# TOYOTA TECHNICAL SERVICE BULLETIN

REF.: BODY  
 NO.: BO95-006  
 DATE: JULY 28, 1995  
 MODEL: GB (AVALON)

## AVALON WINDSHIELD MOLDING WIND NOISE

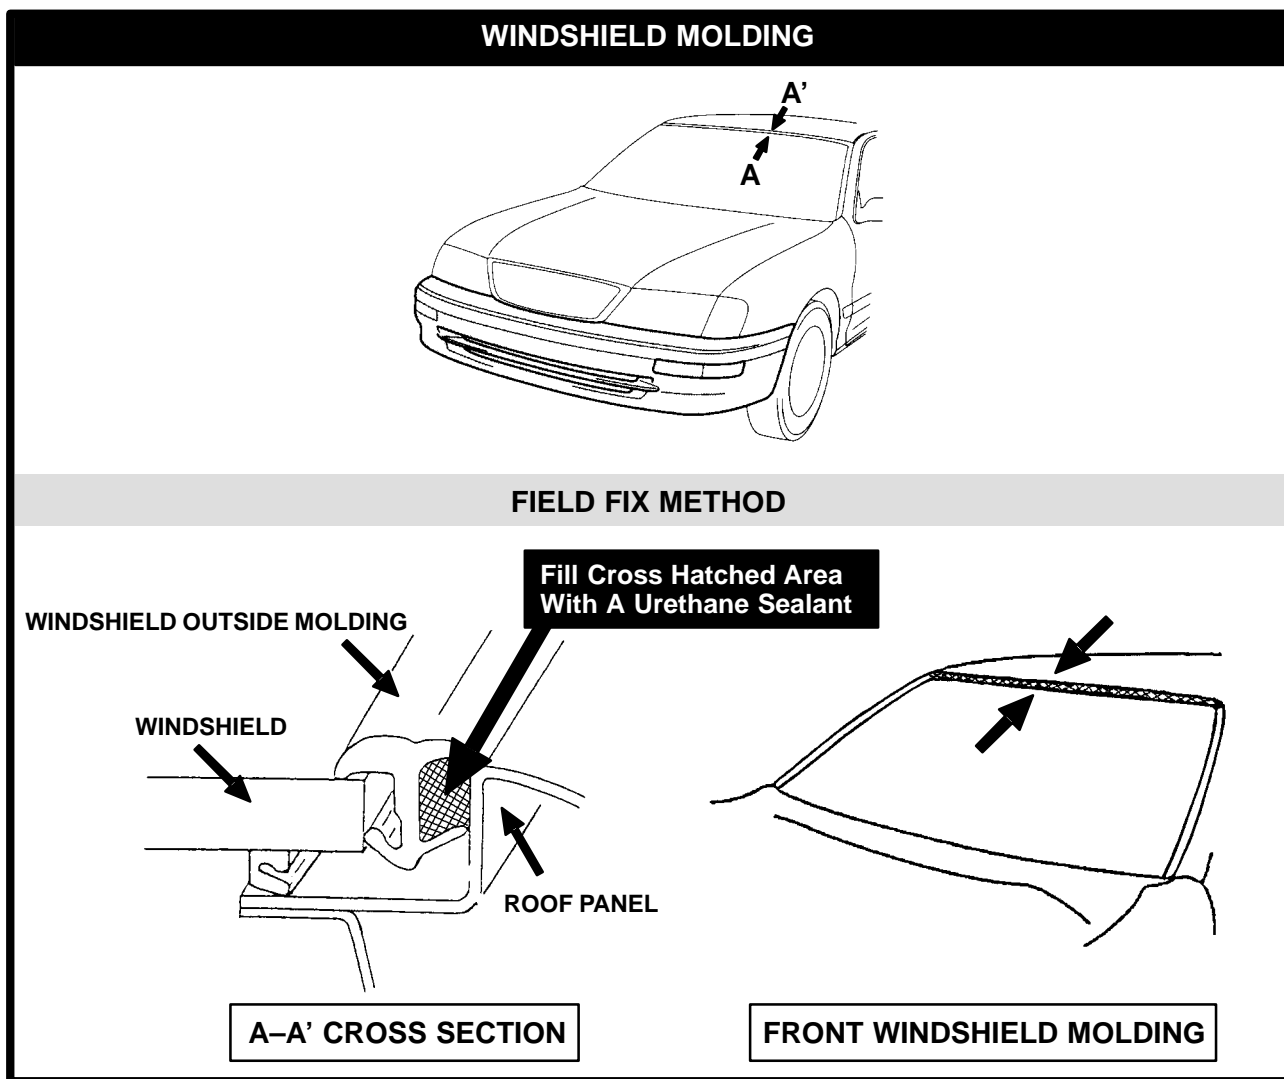
TMM has implemented a production process change to improve windshield sealing.

To eliminate whistling noise from the windshield top outside molding, fill in the windshield channel with a urethane sealant such as **3M Window Weld Re-sealant** or equivalent (refer to illustration below for proper application).
